Appl. No. 10/676,959  
Amdt. Dated January 23, 2006  
Reply to Office action of November 22, 2005

**Amendments to the Drawings:**

The attached sheet of drawings includes changes to Fig. 2C and Fig. 2E.

FIG. 2C

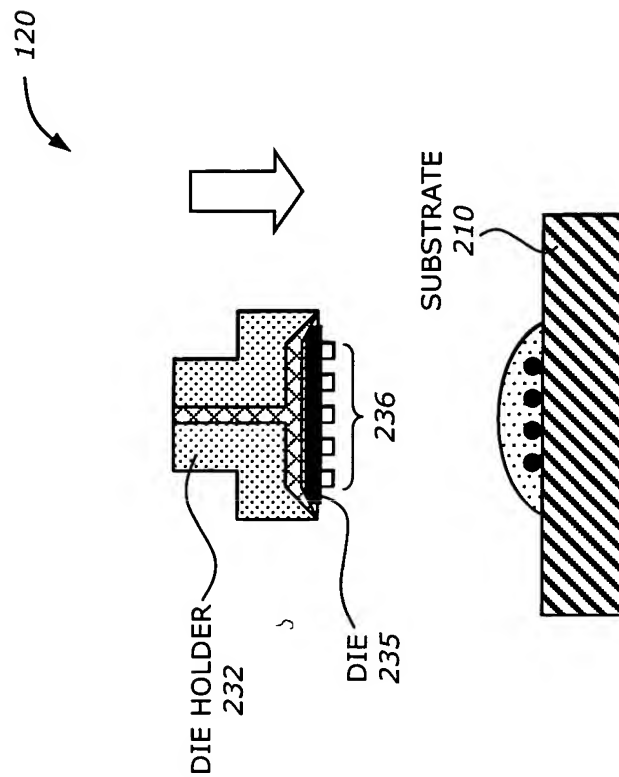
Figure 2C: Reference "236" is added to show the bumps of the die 235.

FIG. 2E

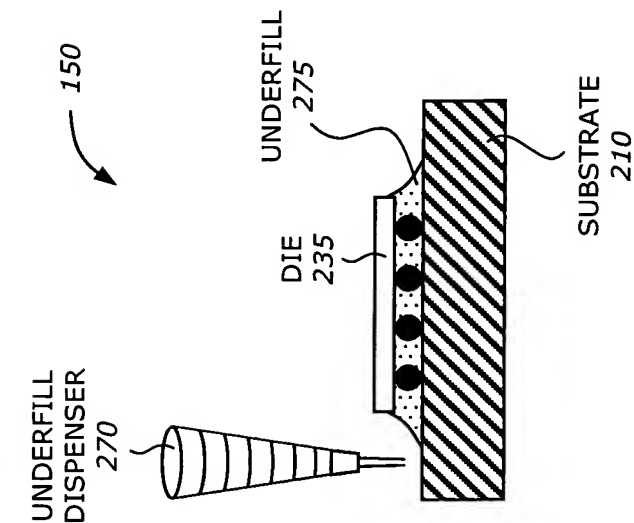
Figure 2E: Reference "130" is changed to "140".
